AGENDA
HAILEY PLANNING & ZONING COMMISSION
Tuesday, September 4, 2018
Hailey City Hall
5:30 p.m.

PH 1 Consideration of Design Review Application by The Counterbalance, represented by Mark Gasenica, for a 3084 square foot two-story commercial building. This proposal includes a commercial retail and storage area on the main floor (2188 square feet) and an office and storage area on the second floor (896 square feet). The proposed use of the commercial area is for a coffee shop. The project is located at 811 N 1st Ave, (Taylor Sub Lot 1), in the Business (B) Zoning District. **ACTION ITEM**

Design Review Application by The Counterbalance, represented by Mark Gasenica, for a new 3,084 square foot two-story commercial building. This proposal includes a commercial retail and storage area on the main floor (2,188 square feet) and an office and storage area on the second floor (896 square feet). The proposed use of the commercial area is for a coffee shop. The project is located at 811 North 1st Avenue, (Lot 1, Taylor Subdivision), in the Business (B) Zoning District. The existing approximately 1,200 square foot building is planned to be removed.

the counterbalance
 SITE PLAN

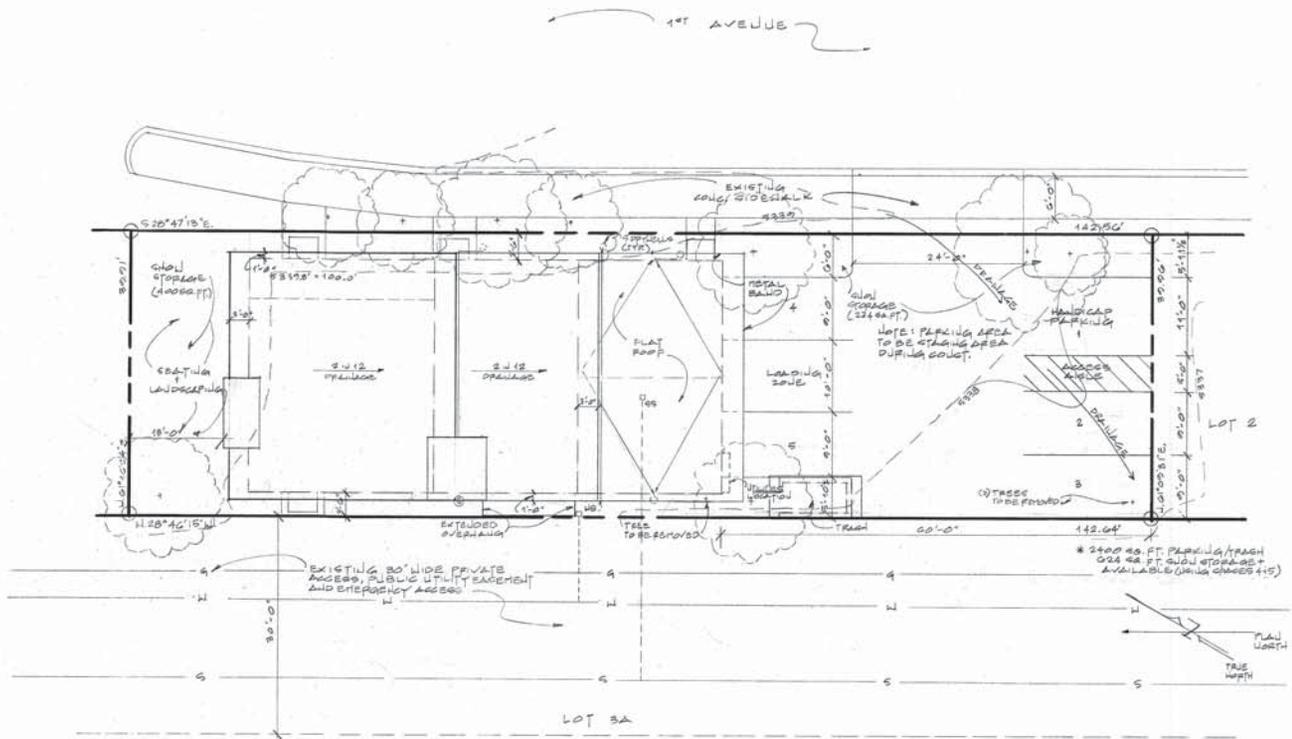
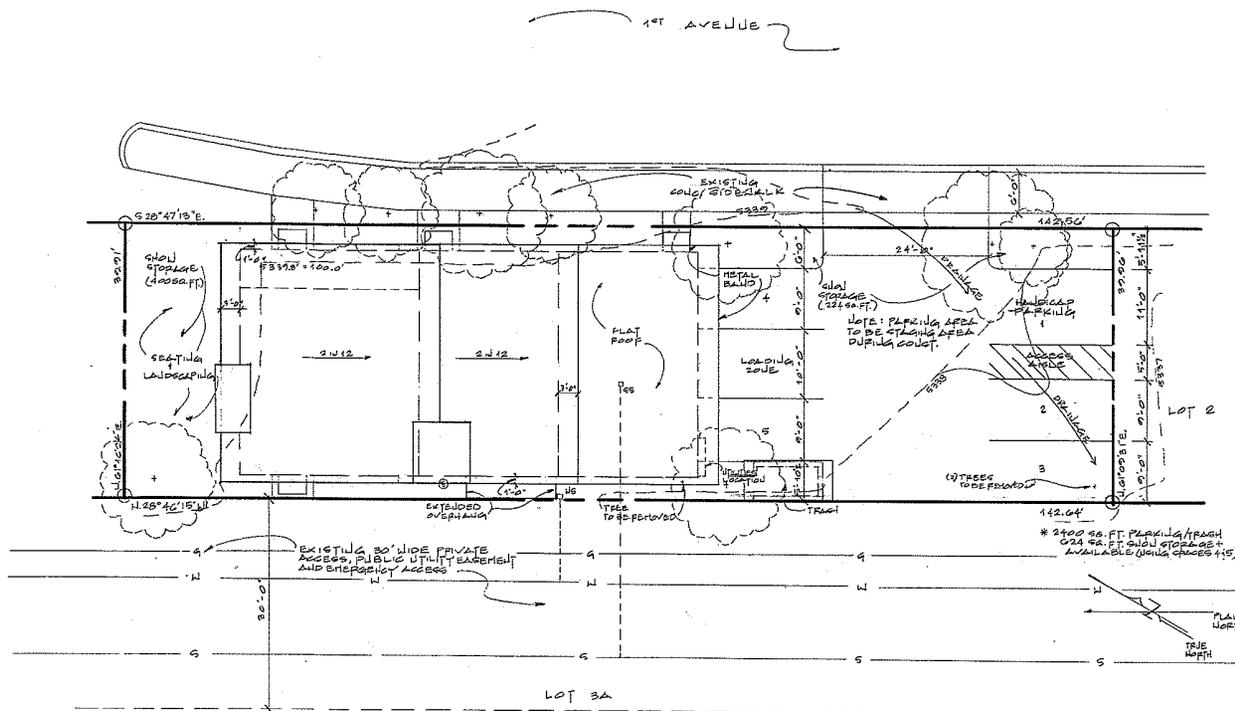
Staff Comments	<i>The on-site parking is located in a parking lot to the south side of the building. Some parking is available on the street. The applicant should show in the</i>

Staff Comments	<i>The site plan proposes 2400 square feet of hardscape (parking, vehicle and pedestrian areas). 25% of this (640 square feet) is required as a snow storage area. 624 square feet of snow storage is shown (spaces 4 and 5).</i>
<input checked="" type="checkbox"/>	<input type="checkbox"/>	<input type="checkbox"/>	17.06.080(A) 1j	<p>c. Snow storage areas shall not be less than 25% of the improved parking and vehicle and pedestrian circulation areas.</p>
			Staff Comments	<i>See Standard (i) above.</i>
<input checked="" type="checkbox"/>	<input type="checkbox"/>	<input type="checkbox"/>	17.06.080(A) 1k	<p>d. A designated snow storage area shall not have any dimension less than 10 feet.</p>
			Staff Comments	<i>Snow storage area meets requirements.</i>
<input checked="" type="checkbox"/>	<input type="checkbox"/>	<input type="checkbox"/>	17.06.080(A) 1l	<p>l. Hauling of snow from downtown areas is permissible where other options are not practical.</p>

<i>Staff Comments</i>	<i>The plant material shown has attention to color and texture.</i>
<input checked="" type="checkbox"/> ?	<input type="checkbox"/>	<input type="checkbox"/>	17.06.080(A) 4g	g. Storm water runoff should be retained on the site wherever possible and used to irrigate plant materials.
			<i>Staff Comments</i>	<i>Runoff should be addressed in the southwest corner.</i>

- j) A letter from Clearcreek Disposal shall be provided stating that the location and design is adequate for rolling can pickup. If a change is made, a Design Review modification should be submitted.

the counterbalance
 LANDSCAPE PLAN

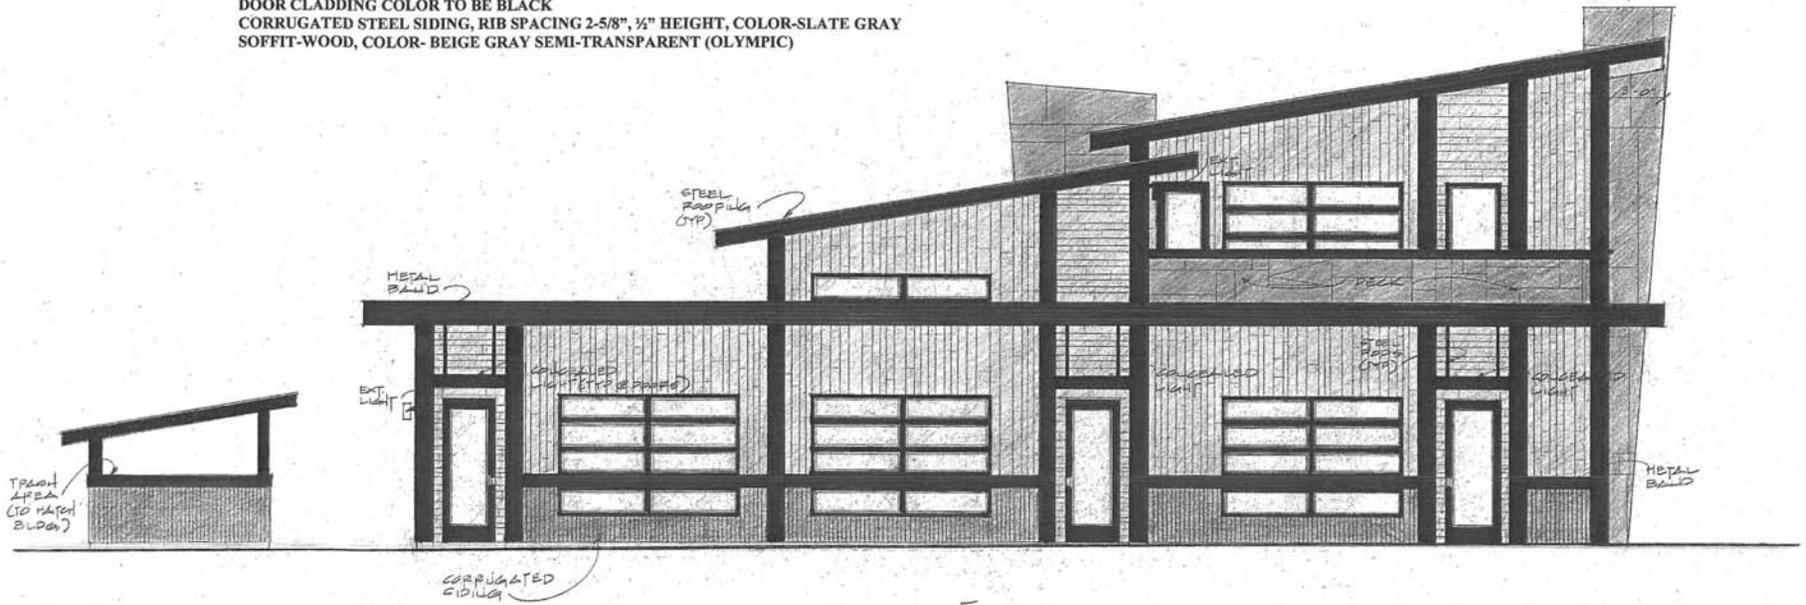
Compliant			Standards and Staff Comments	
Yes	No	N/A	City Code	City Standards and Staff Comments
<input checked="" type="checkbox"/>	<input type="checkbox"/>	<input type="checkbox"/>	17.06.080(A) 4a	a. Only drought tolerant plant species and/or xeriscape specific plant materials shall be used, as specified by the Hailey Landscaping Manual or an approved alternative.
			Staff Comments	<i>Plant materials will be appropriate for the environment. Comments from the City Arborist (if any) will be brought to the meeting.</i>

<i>Staff Comments</i>	<i>Proposed landscaping is varied. A combination of trees, shrubs, native grasses and wildflowers will be utilized to soften the site.</i>
<input type="checkbox"/>	<input type="checkbox"/>	<input checked="" type="checkbox"/>	17.06.080(A) 4e	e. Seasonal plantings in planter boxes, pots, and/or hanging baskets shall be provided to add color and interest to the outside of buildings in the LI and SCI-I zoning districts.
			<i>Staff Comments</i>	<i>N/A</i>
<input checked="" type="checkbox"/> ?	<input type="checkbox"/>	<input type="checkbox"/>	17.06.080(A) 4f	f. Plantings for pedestrian areas within the B, LB, TN and SCI-O zoning districts shall be designed with attention to the details of color, texture and form. A variety of trees, shrubs, perennials, ground covers and seasonal plantings, with different shapes and distinctive foliage, bark and flowers shall be used in beds, planter boxes, pots, and/or hanging baskets.
